# Mesa Public Library Noise Issues

## Wall Openings – Mitigation Option 2

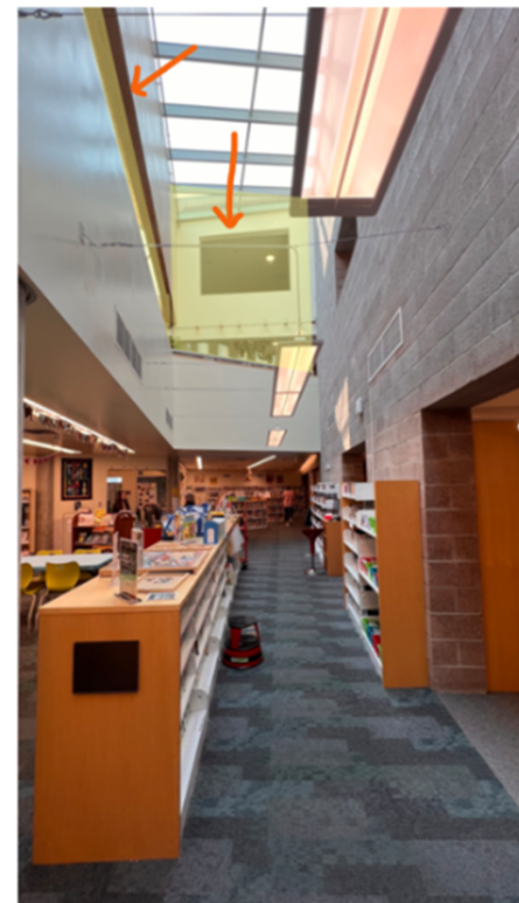
- Instilling sound absorptive materials on the existing walls within the upper clearstory area, as well as on the underside of the structure in the reference lobby adjacent to the reference desk, would help reduce the perceived noise for staff working at the desk.
- It is anticipated that this acoustic benefit would be modest relative to the cost of adding wall panels to this area.
- Treating a large surface area of walls and exiting is expected to yield approximately 3-5 dB reduction in noise levels at the desk, specially for sound originating from the ground level and the lobby areas.
- These areas are acoustically linked due to their architectural connectivity.
